**NPDES PERMIT FACT SHEET  
ADDENDUM**

Application No. PA0253308  
APS ID 988353  
Authorization ID 1264846

Applicant Name	<u>AK Steel Corp</u>	Facility Name	<u>AK Steel Hillside Landfill</u>
Applicant Address	<u>PO Box 832</u> <u>Butler, PA 16003</u>	Facility Address	<u>2301 Duss Avenue</u> <u>Ambridge, PA 15003</u>
Applicant Contact	<u>Frank Monteleone</u>	Facility Contact	<u>Same as Applicant</u>
Applicant Phone	<u>(724) 284-3367</u>	Facility Phone	<u>Same as Applicant</u>
Client ID	<u>139851</u>	Site ID	<u>668156</u>
SIC Code	<u>9999</u>	Municipality	<u>Harmony Township</u>
SIC Description	<u>Public Admin. - Nonclassifiable</u> <u>Establishment</u>	County	<u>Beaver</u>
Date Published in PA Bulletin	<u>April 20, 2019</u>	EPA Waived?	<u>Yes</u>
Comment Period End Date	<u>May 20, 2019</u>	If No, Reason	<u></u>
Purpose of Application	<u>Application for a new NPDES permit for discharge of treated Industrial</u>

Figure 1  
Reproduction of PADEP "Unnamed Tributary" USGS  
StreamStats Drainage Area Delineation with  
Imagery Base Map

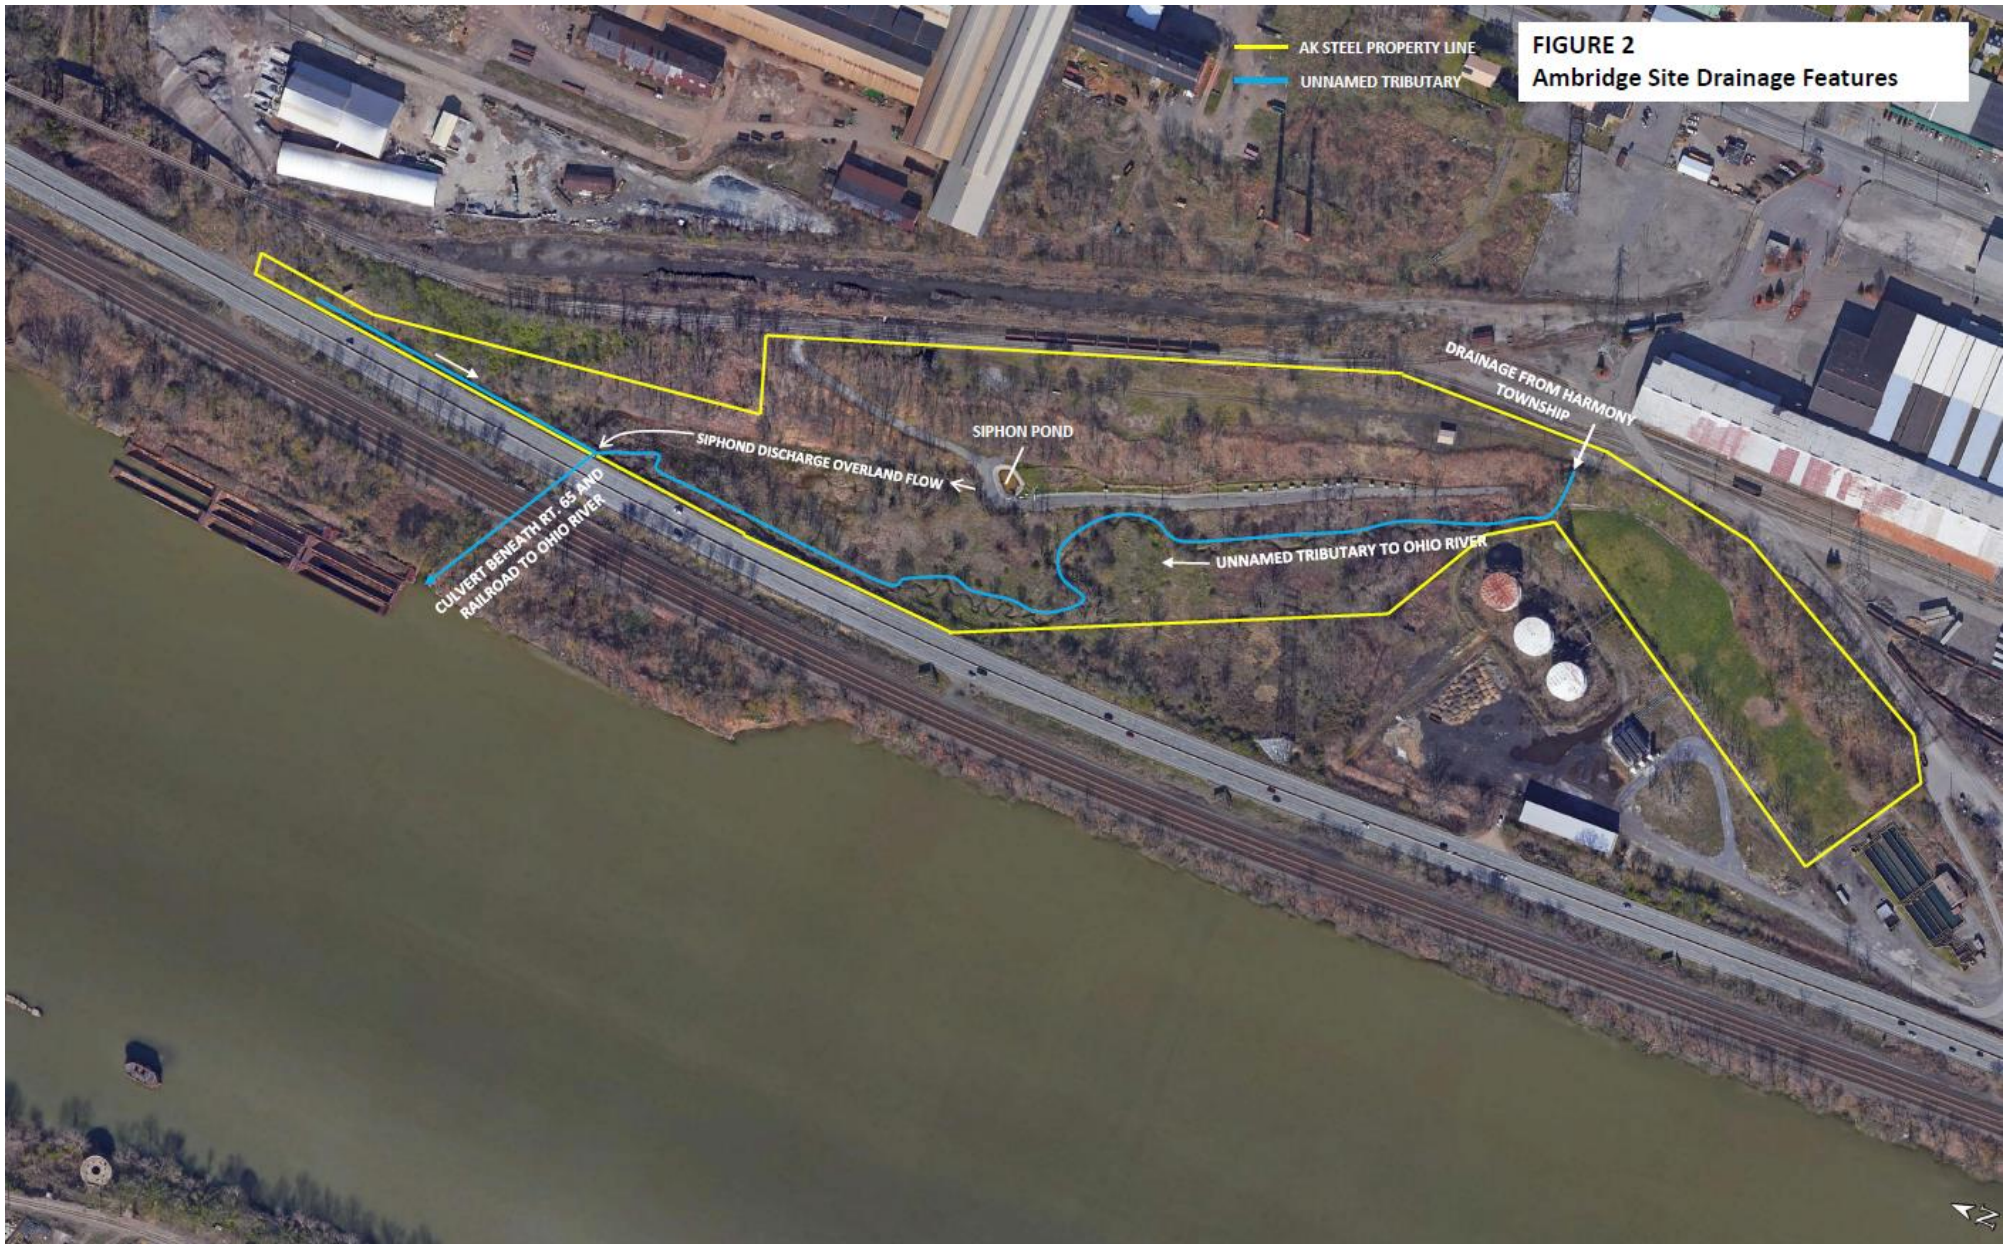
The Fact Sheet does not clearly identify the receiving stream and appears to contain contradictory information in this regard. The receiving stream's 'NHD COM ID' (national common identification, Common ID) is listed as 99681044 on page 3 of the Fact Sheet. Common ID 99681044 is Legionville Run. However, as stated by the Department on page 2 of the Fact Sheet, the receiving stream for the Outfall 001 discharge is not Legionville Run, but is an Unnamed Tributary to the Ohio River.

The Fact Sheet then identifies the receiving stream as an Unnamed Tributary to the Ohio River with a drainage area of 0.0399 square miles, as delineated by the USGS StreamStats program (see Fact Sheet pages 3 and 12). The Fact Sheet contains the following statement at page 6:

A reproduction of the Department's USGS StreamStats drainage area delineation is attached, with "imagery" selected as the base map. See attached Figure 1.

The discharge stream that has been identified by both the Department and AK Steel is an unnamed tributary to the Ohio River. The NHD COM ID that was included in the Fact Sheet was a typographic error and should not have been included in the Fact Sheet. The unnamed tributary to the Ohio River is not an identified stream; therefore, the stream has no NHD COM ID number. However, the Department conducted a stream survey on June 18, 2019 and verified that it is a stream; the report is included in Attachment E. The Southwest Regional Office has submitted a request to DEP's Central Office to update its GIS system to identify the stream.

FIGURE 3  
 USGS STREAMSTATS REPORT  
 FOR UNNAMED TRIBUTARY

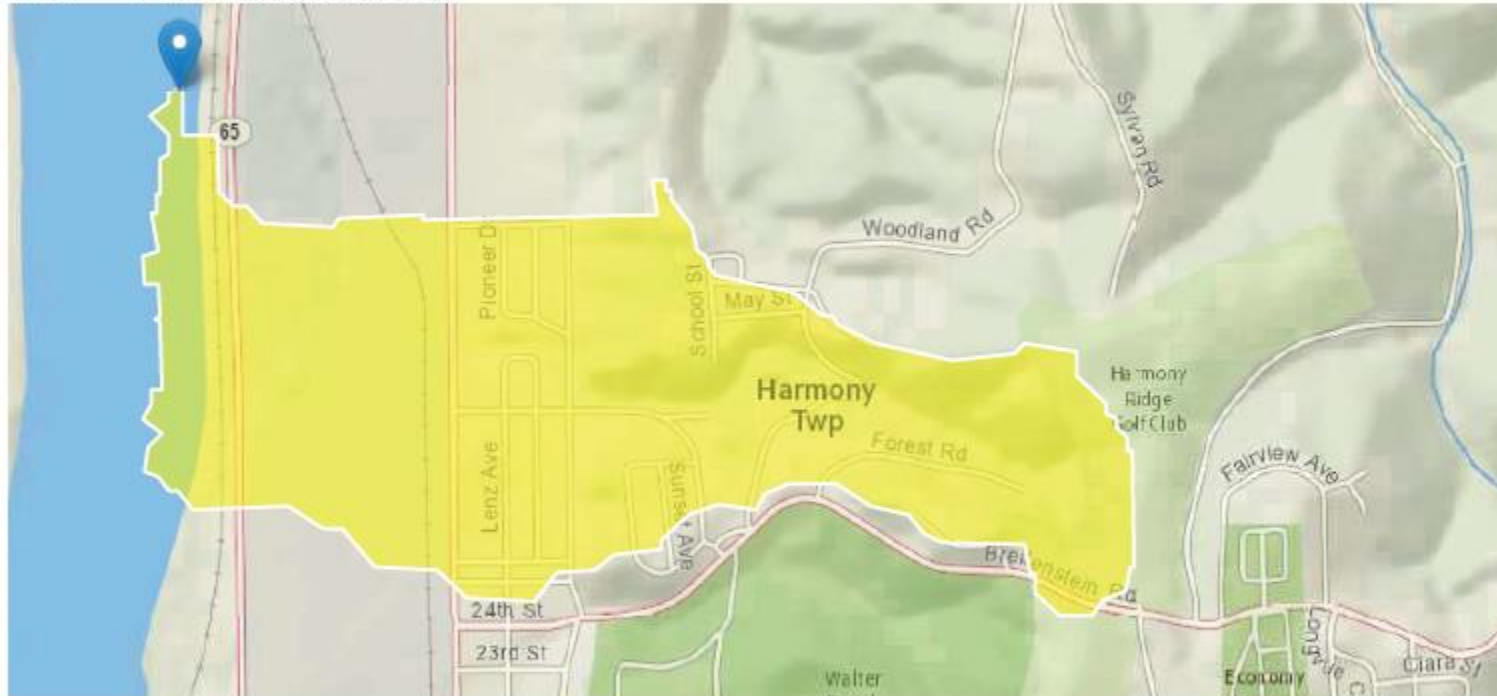
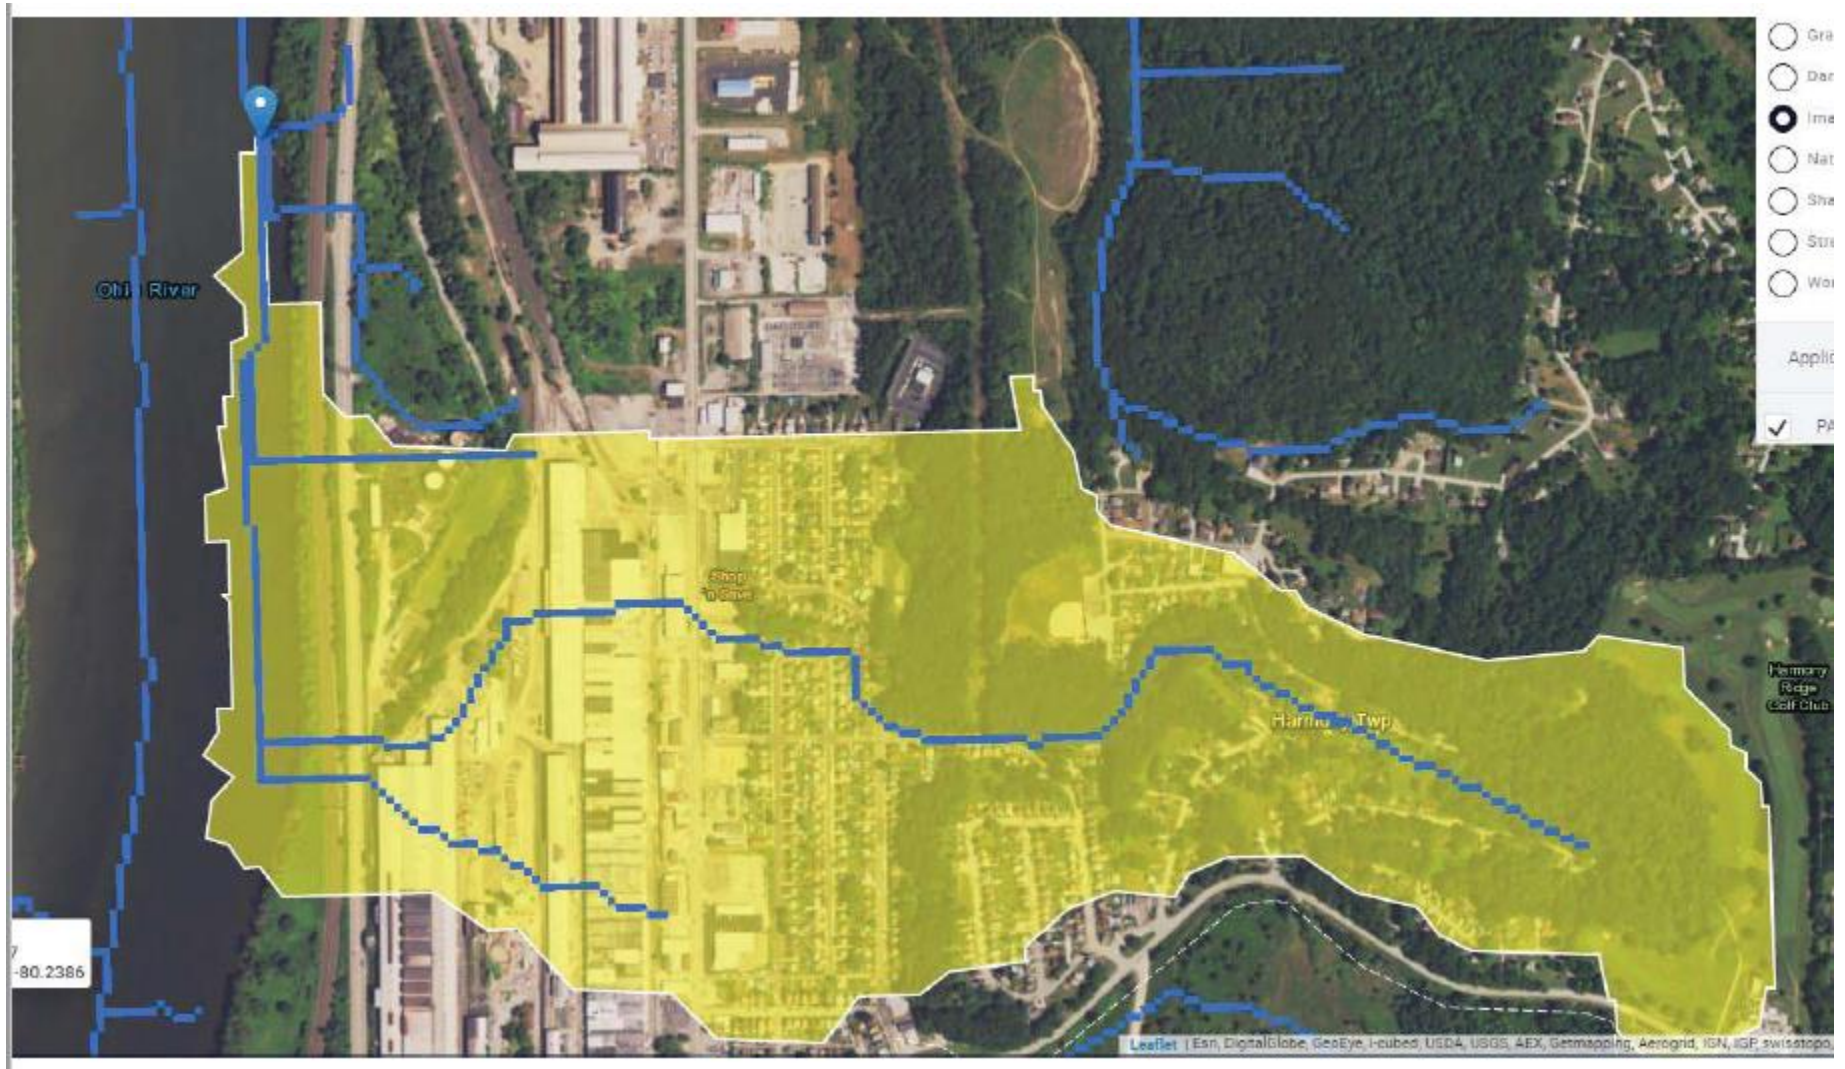
Figure 2 originates upstream of the Hillside Landfill site, such that the drainage area includes portions of Harmony Township and is larger than the 0.0399 square miles identified by the Department. An output from USGS StreamStats program for the unnamed tributary shown on Figure 2 is provided as Figure 3. The drainage area and Q7,10 of the unnamed tributary are 0.46 square miles and 0.00262 cfs, respectively, as calculated by the USGS StreamStats program. The unnamed tributary shown on Figure 2 is the first "stream" in the common sense of the word which receives the site discharge.

AK Steel believes the streamflow for the unnamed tributary shown on Figure 2 should be used for calculation of WQBELs (0.00262 cfs Q7,10). Using this Q7,10 stream flow and the site discharge flow rate of 0.004 mgd, AK Steel calculated WQBELs for boron, dissolved iron and manganese as follows:

Pollutant	Monthly Average WQBEL (mg/l)	Daily Maximum WQBEL (mg/l)
Total Boron	2.2	4.4
Dissolved Iron	0.36	0.72
Total Manganese	1.4	2.8

AK Steel requests that the WQBELs listed in the table above be included as the final limits in the NPDES permit.

The first comment from AK Steel discusses the receiving stream for the Outfall 001 discharge. AK Steel stated that the Fact Sheet didn't clearly identify the receiving stream because the NHD COM ID was listed as 99681044, which is the ID for Legionville Run but the fact sheet listed the receiving stream as an unnamed tributary to the Ohio River. Additionally, AK Steel claims that the Department improperly selected the drainage area and Q7-10 of the receiving stream. AK Steel claims the discharge from the Siphon Pond flows as overland flow to an unnamed tributary to the Ohio River. AK Steel believes that the discharge from the site should be analyzed just before the stream is culverted under the highway and railroad tracks to the Ohio River and not at the end of pipe of the Siphon Pond. With the discharge being analyzed at this point, AK Steel believes that the drainage area should be 0.46 square miles and the Q7-10 flow should be 0.00262 cfs; therefore, changing the water quality based effluent limitations to the following:

Pollutant	Average Monthly Limit (mg/L)	Daily Maximum Limit (mg/L)
Total Boron	2.2	4.4
Dissolved Iron	0.36	0.72
Total Manganese	1.4	2.8

When the Department conducted the water quality analysis of the discharge, discharge data was evaluated at the point of discharge from the Siphon Pond. After further evaluation, it was determined that the discharge is not directly to a stream but to a wetland prior to the unnamed tributary of the Ohio River. During the stream survey, it was determined that the point of first use was after this wetland at the unnamed tributary to the Ohio River. Therefore, the water quality analysis in the draft permit was conducted with the wrong drainage area and Q7-10 flow. Using the revised drainage area and Q7-10 flow, the effluent limitations for total boron, dissolved iron, and total manganese have been changed to monitor only. The water quality analysis is described later in this Addendum in more detail.
